# Outer Dowsing Offshore Wind

## The Applicant's Response to T.H. Clements' Dust Report, Assessment and Conclusions

Document Reference: 21.20

## **The Applicant's Response to T.H. Clements' Dust Report, Assessment and Conclusions**

**Figure 1: TSP Source Apportionment [Table 4-6 [REP1-050](#)]**

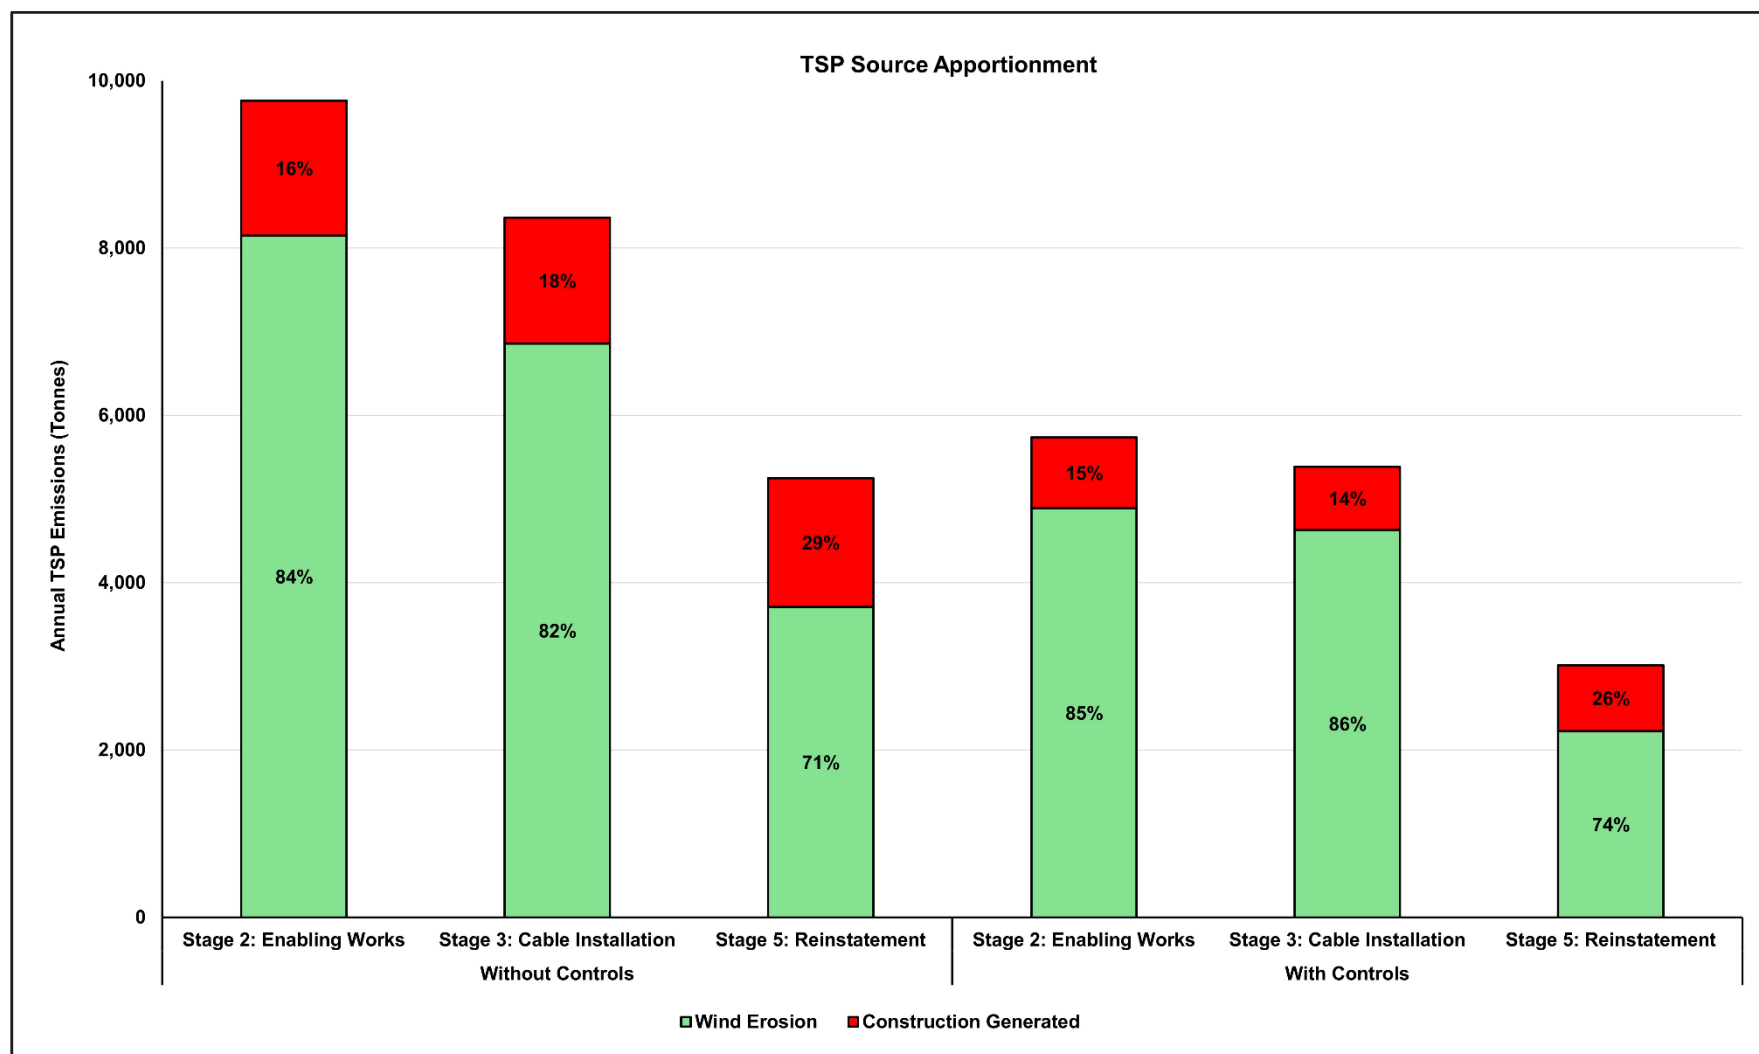
The Applicant has undertaken further analysis of the data presented in Table 4-6 [REP1-050]. The emissions across each modelled scenario have been aggregated and grouped into two categories: wind erosion sources vs. construction activity sources. The data is detailed in Table 2, while the percentage contributions are illustrated in Figure 1.

During the With Controls scenario, the total mass of construction dust (TSP) modelled across the 48.3km onshore ECC segment is 14,136 tonnes. This illustrates the conservative nature of the assessment. 83% is generated from wind erosion (11,750 tonnes).

Across each of the modelled scenarios, wind erosion consistently accounts for over 70% of total emissions (Figure 1). Dust soiling risks are particularly high during the Stage 2: Enabling Works and Stage 3: Cable Infrastructure Installation phases (Section 2.0), where wind erosion contributes over 85% of emissions. Wind erosion is the dominant source. In response to this, wind erosion emission input calculations have been reviewed, with reference to the guidance documents outlined in Section 2.1.
